**RE: RE-ZONING AND DEVELOPMENT PERMIT APPLICATION: 1042-1044 RICHARDSON STREET**

Attn: City of Victoria Planning staff (Alec Johnston):

Responses and actions taken in response to the review are addressed to each individual department in this letter, in the same order that they were presented to the applicant in the Application Review Summary (Dated October 20, 2020). In addition to these responses, and revisions to plans, the following supplementary documents have been produced and are included in re-submission:

**Figure 1: Typical bedroom elevation – North and East Elevations**

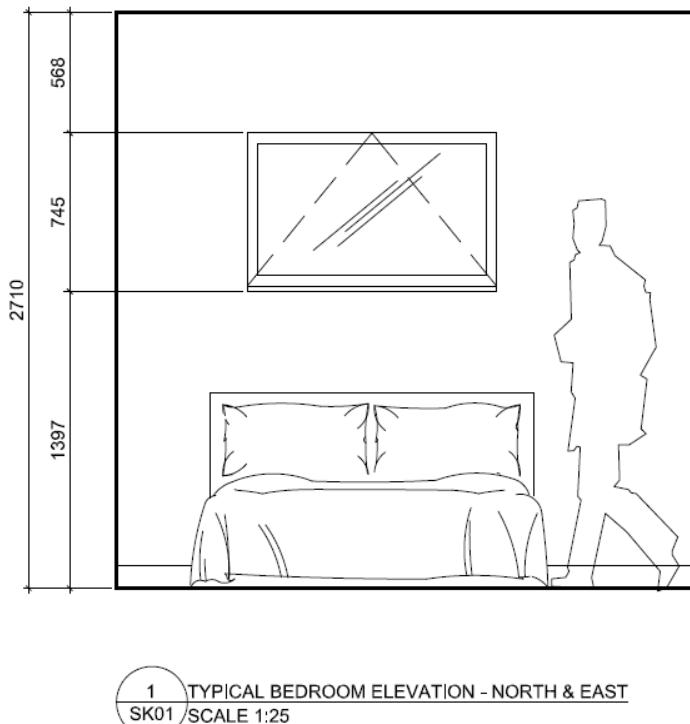
**Response:** Referring to Section 8.8 of the Fairfield Neighbourhood Plan (p. 77), “new development is [to be] neighbourly, compatible and transition sensitively to adjacent development, particularly adjacent Traditional Residential areas.” While this specifically references sites neighbouring traditional residential areas, and this site is surrounded by urban residential properties (multi-residential 3-4 storey structures), it is nonetheless worth explaining how this proposal is compatible to, and transitions to neighbouring developments:

- Window placements were designed to avoid overlook, as shown in the window overlay. The overwhelming majority of windows facing neighbouring properties are not designed to provide views, but rather airflow and natural light, being placed high in bedrooms (not principal living rooms). See **Figure 1**, which provided an illustration of most windows on the North and East Elevations in the plans.

- Balcony locations were carefully considered in design (see explanations for each elevation):
  - **North:** There is only one set of Juliet balconies placed to the north (facing towards 1035 McClure St.), providing continuity with the overall design on the north facade of the building. Importantly, these windows are placed in the bedroom of the 1-bedroom units, not the principal living spaces. All other windows facing north are placed high in the rooms to provide light and airflow, but not facilitate overlook (as per **Figure 1**).
